## **« Crab-cavity cryomodule and related infrastructure in SPS LSS6 (EYETS 2016-2017) »**

13th HL-LHC TCC, 4th August 2016

ECR, in the  
SPS

# Tunnel vault: new cryogenic distribution line

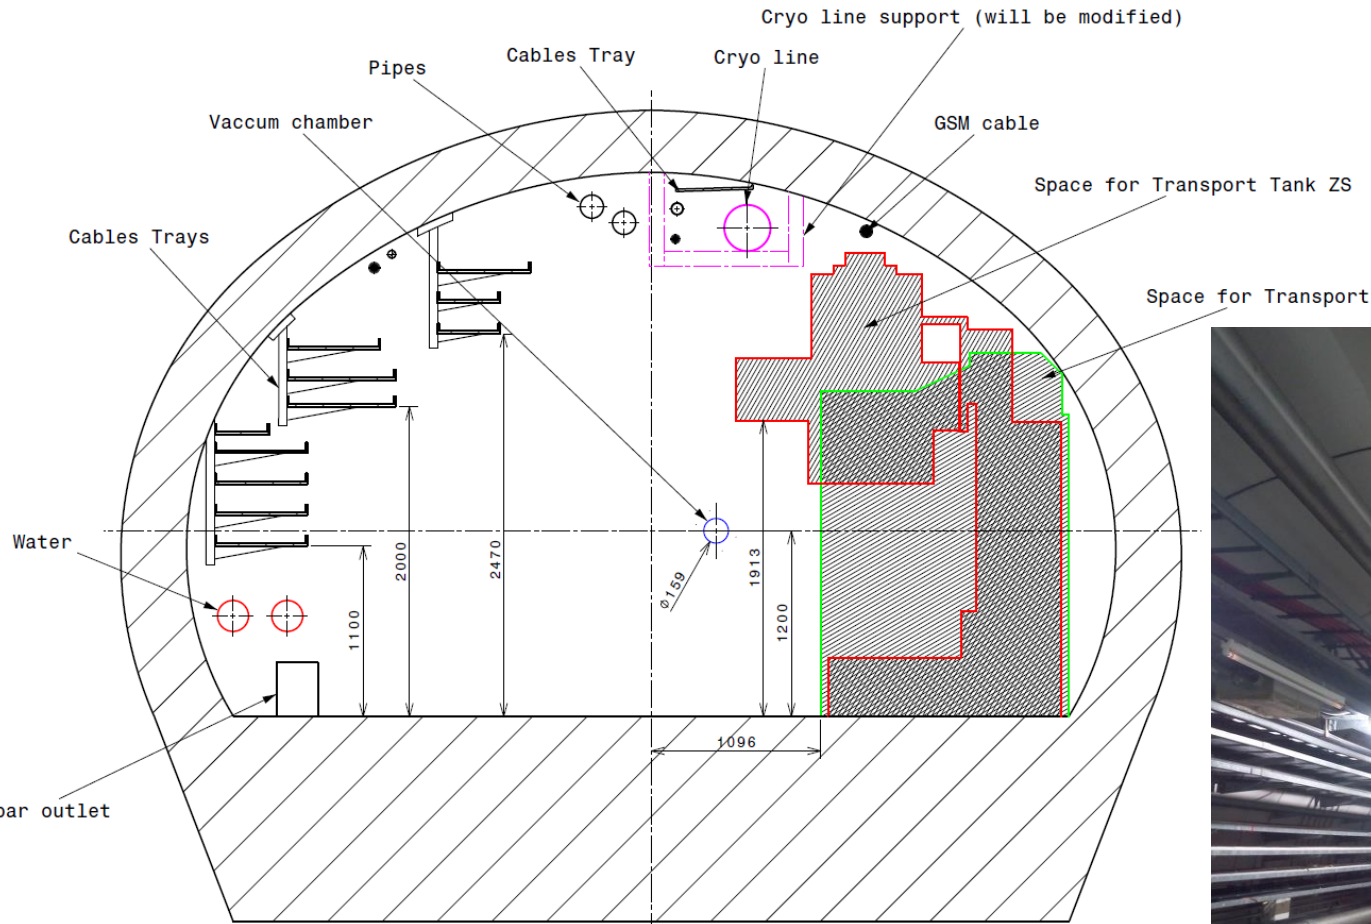
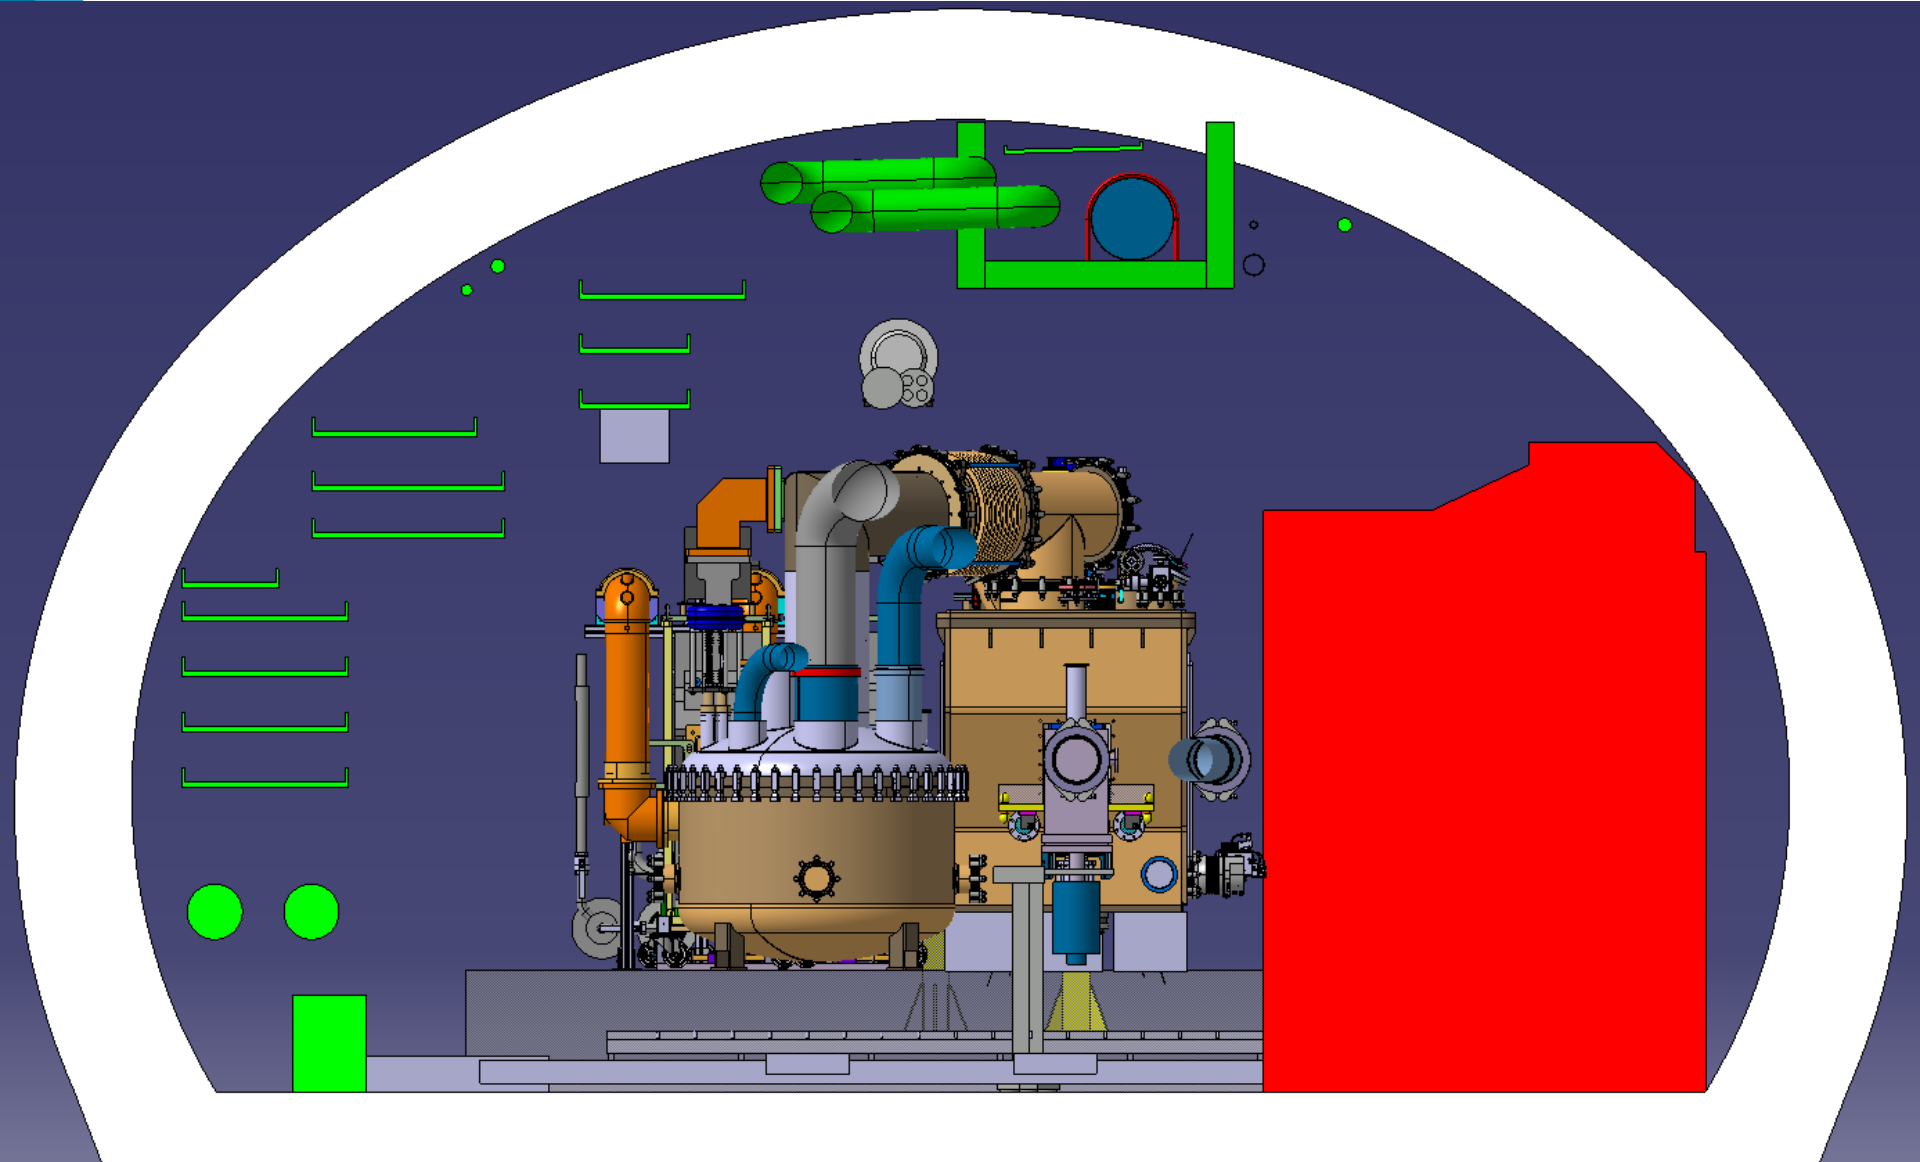
TE-CRG, EN-HE, EN-CV: Colleagues give or request more details on detailed integration of the cryogenic distribution line
